CERN MIT L3 A&C/AMS

AMS02-PDS

Request for [X] waiver [ ] deviation

TITLE OF WAIVER / DEVIATION:
PDS radiated E-field emissions out of specified limits

SIDE B

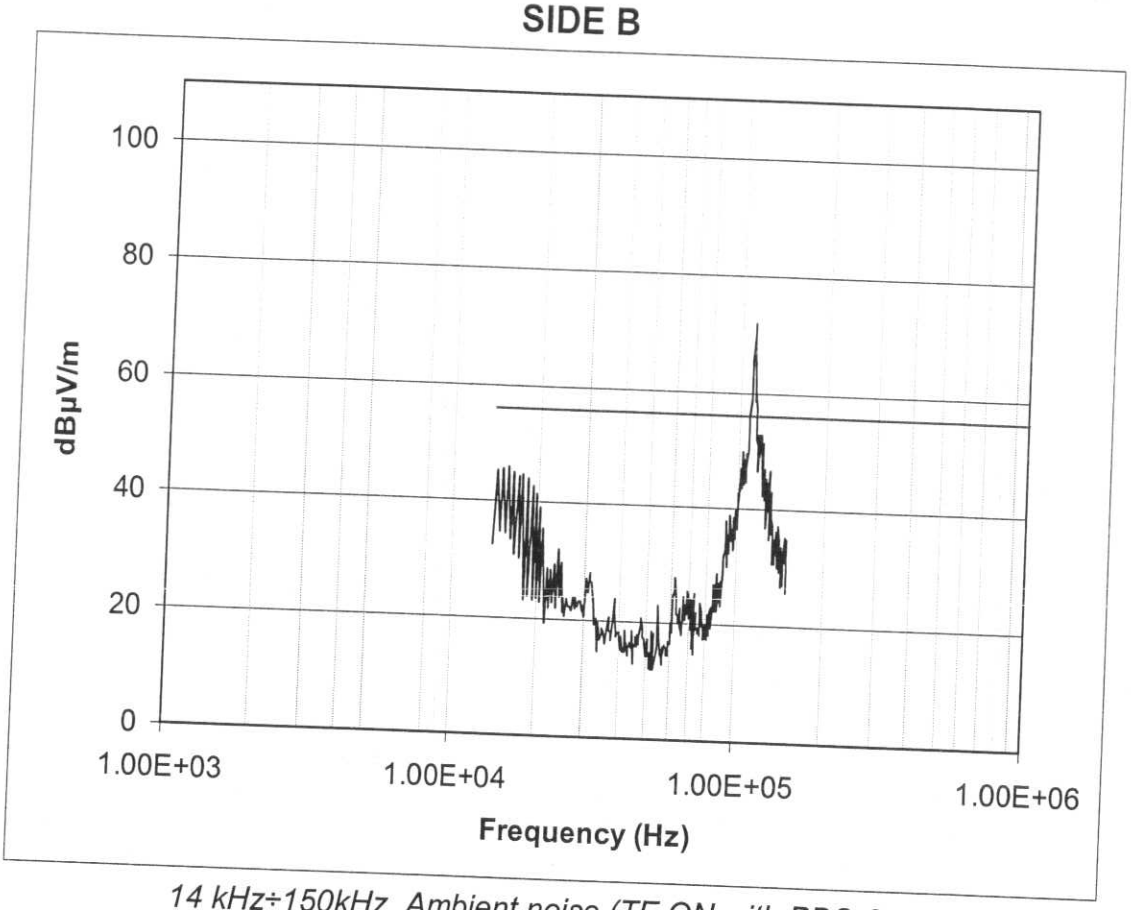
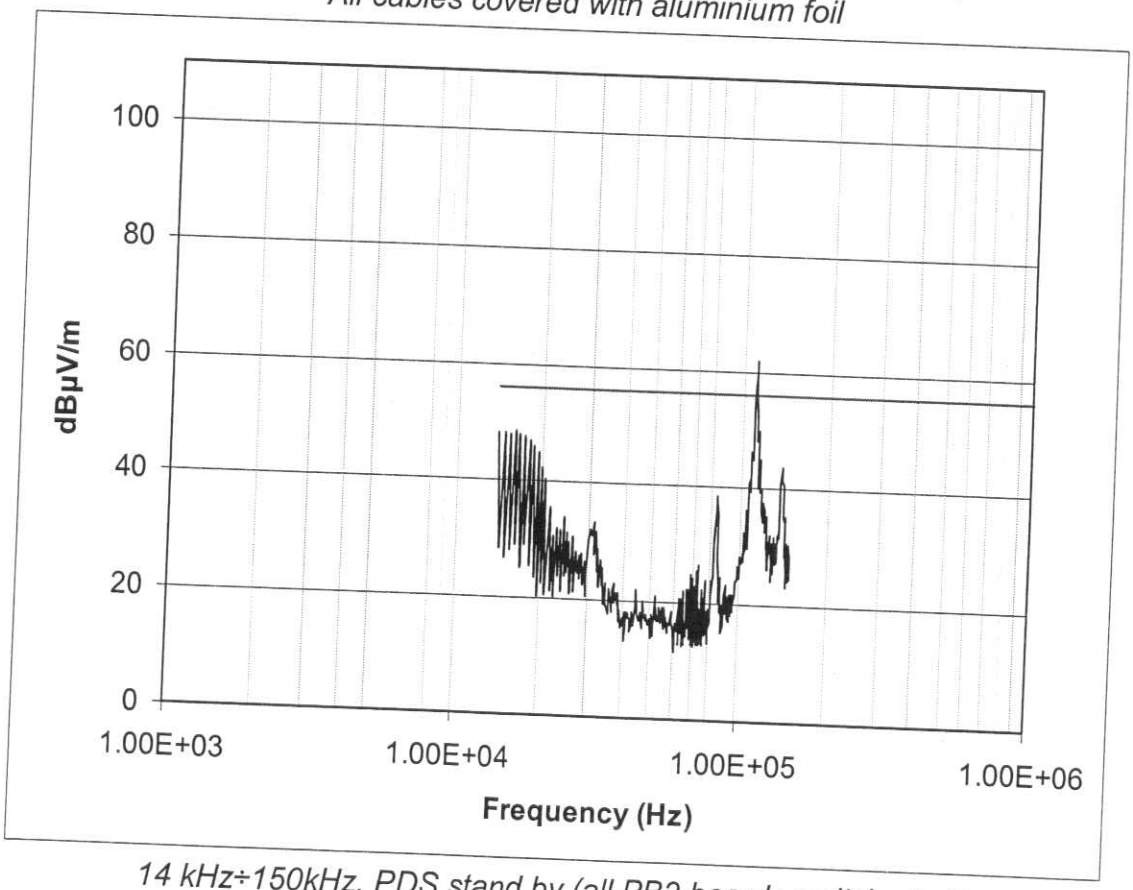
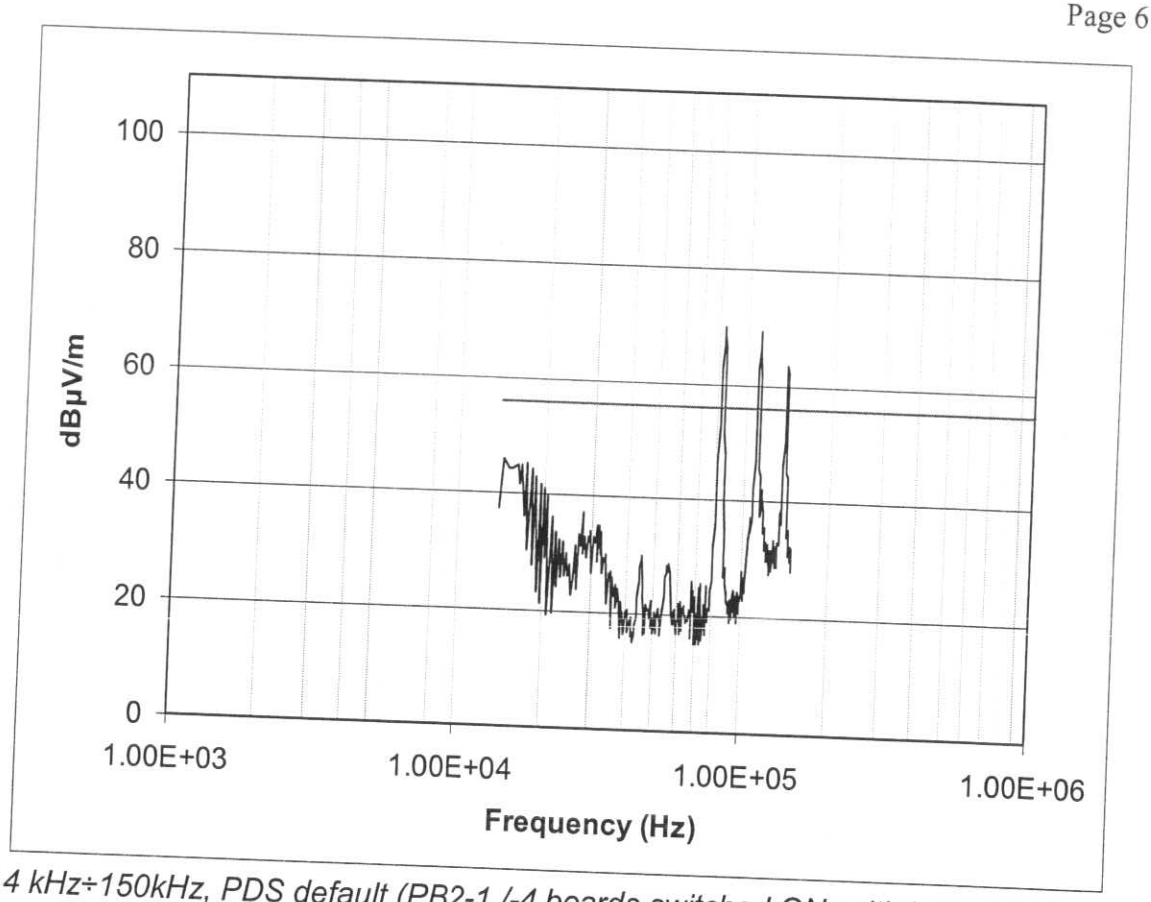
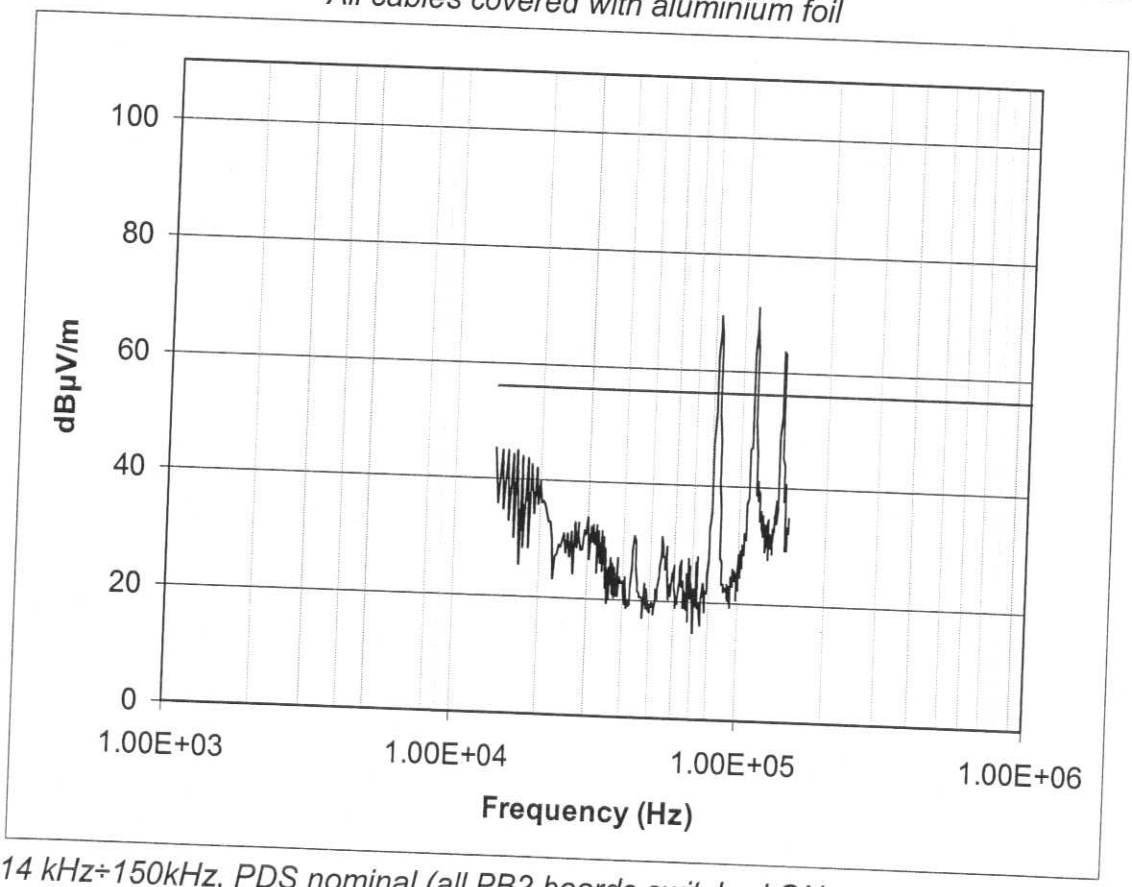
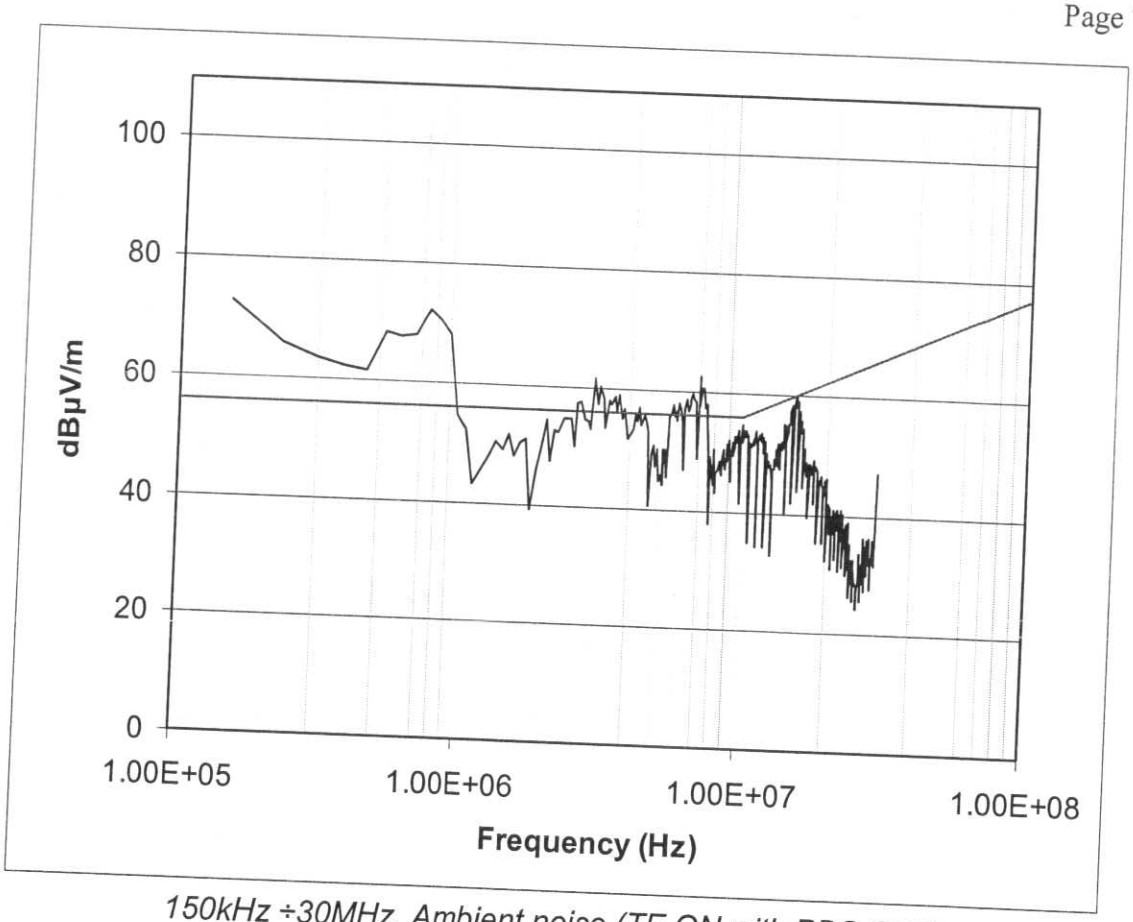
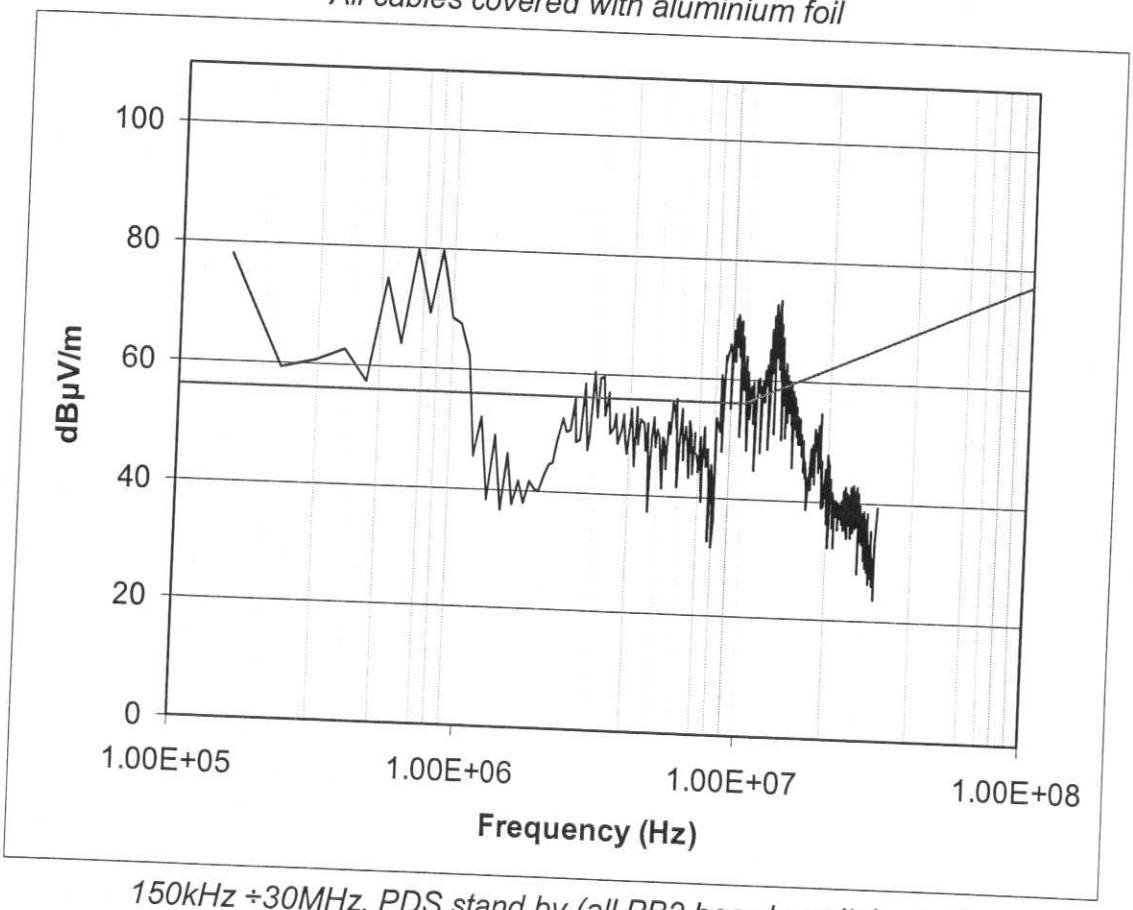
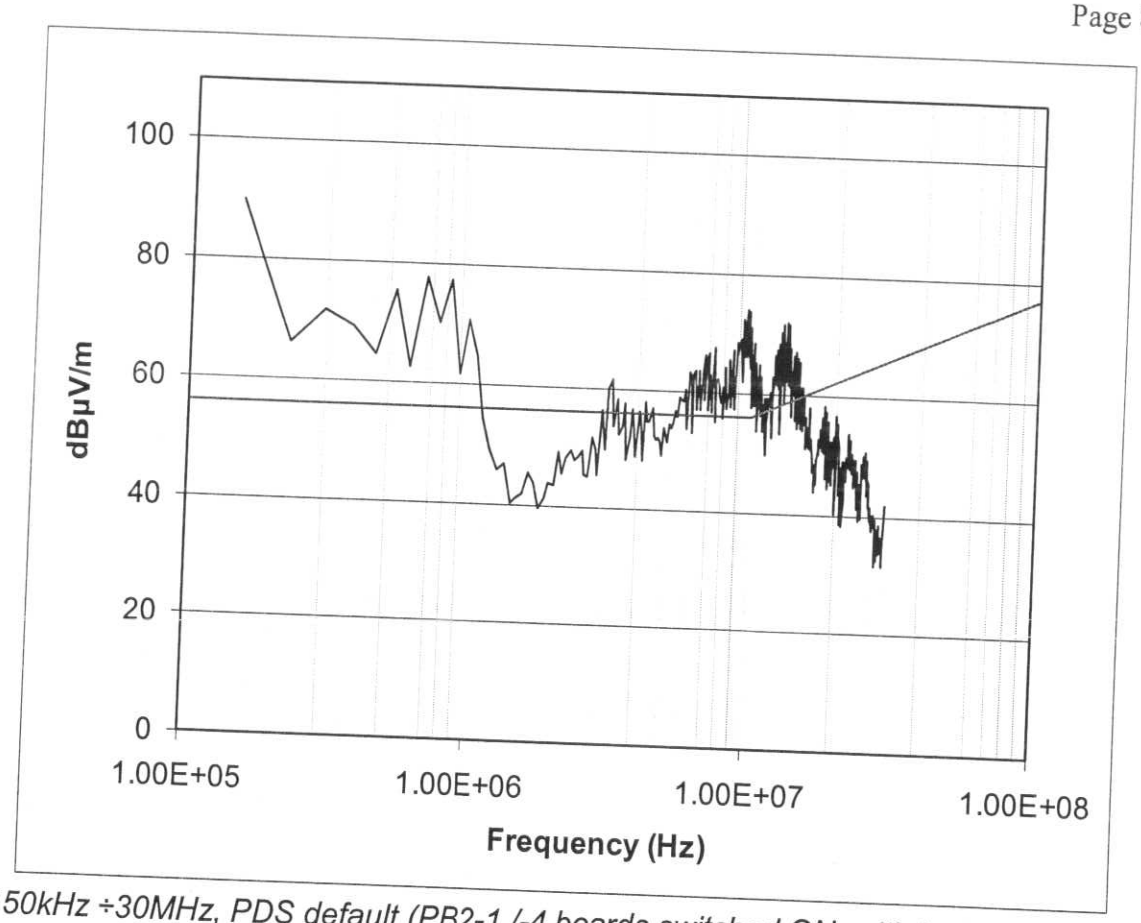
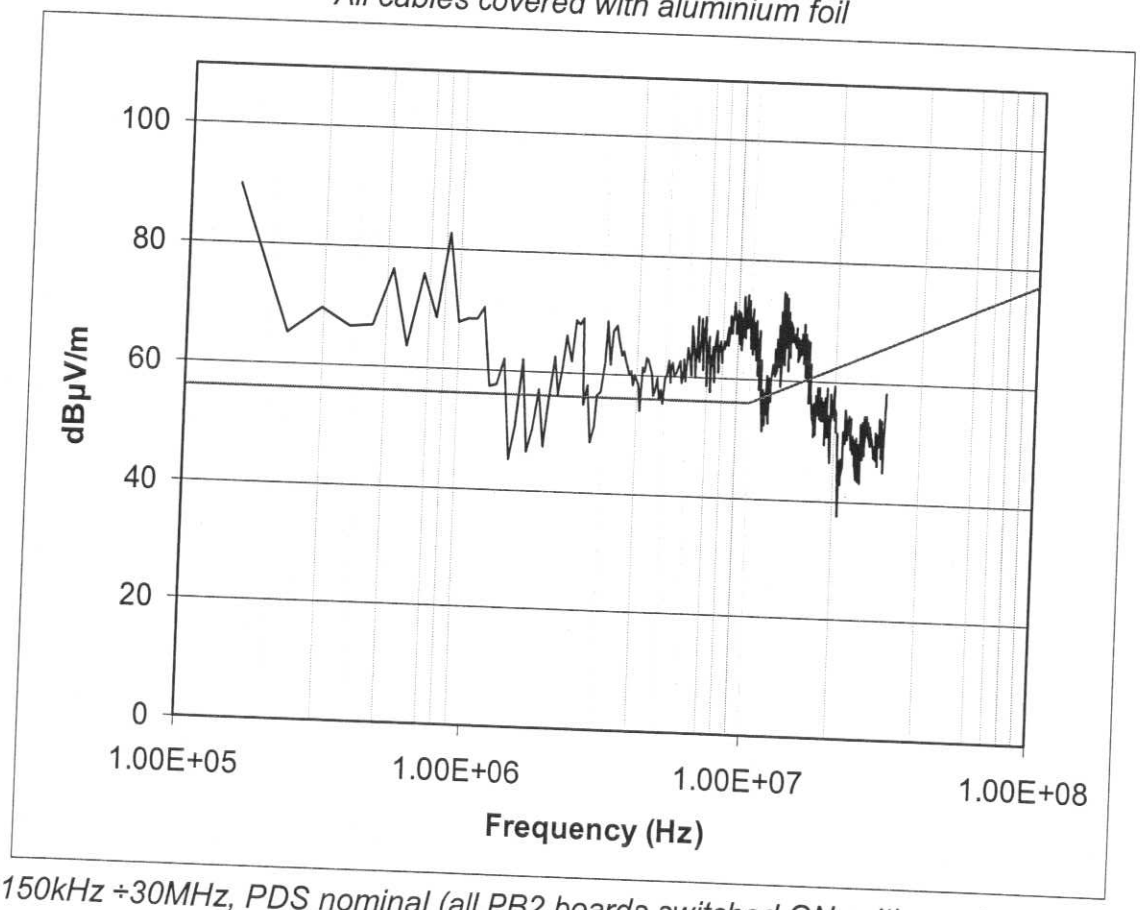
DESCRIPTION OF REQUEST:
To accept that the PDS radiated emissions have been found out of specified limits in the low range of frequency spectrum (from about 70kHz up to about 25MHz) for both side A and side B of unit, see Annex 1.

NEED / REASON FOR REQUEST:
The out-of-spec. value is most probably originated by the use of not shielded cables; shielding performed by wrapping cable bundles with aluminium foil can not be considered as an equivalent solution. Additionally, it is underlined that overall test representativeness is jeopardised by unavailability of flight harness.

PROPOSAL / RECOVERY ACTION:
To use the unit as it is.
